TOWN OF YORKTOWN PLANNING BOARD

PUBLIC MEETING AGENDA YORKTOWN TOWN HALL BOARD ROOM 363 Underhill Avenue, Yorktown Heights, NY 10598

September 27, 2021
7:00 PM

To: Planning Department
From: ABACA
Date: September 13, 2021
Subject: Envirogreen
2040 Greenwood Street; 15.16-1-30

DRAWING NUMBER
A-1

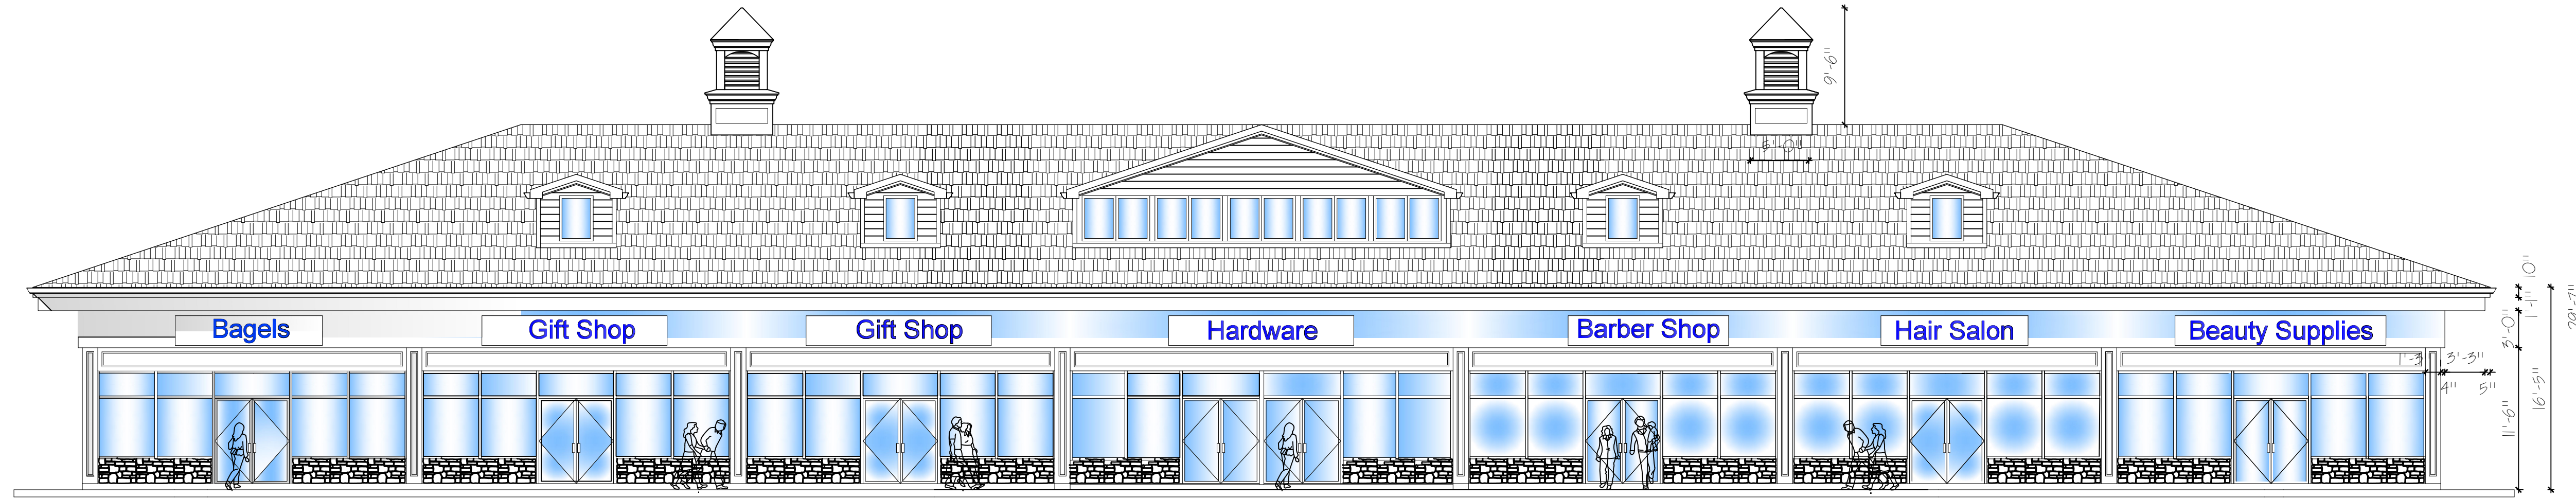
The applicant stated that based on comments received, a revised rendering was submitted for review which included increasing the width of the walkway in front of the building, adding two cupolas and centering the main dormer and access to the site. While the ABACA appreciates the applicant’s response to their comments, the general consensus was that the scale of the cupolas, rooftop dormers and windows seem to be out of proportion to the roof and with each other and suggested for the applicant to study these rooftop elements in further detail. The applicant agreed to look into this and has submitted a revised rendering for the Board’s review on 9/10/21 which included revising the scale of the cupolas and replacing the double windows in the small dormers with single windows.

The Board is generally pleased with the changes submitted but still feels that there is too much window within the large dormer and suggests for the applicant to modify it to include only 4 double units instead of 5. This will allow for additional siding on either side, similar to the modified small dormers. The Board also feels that the window unit heights in all the dormers should be reduced to show more siding above and to separate the head of the units with the raking fascias.
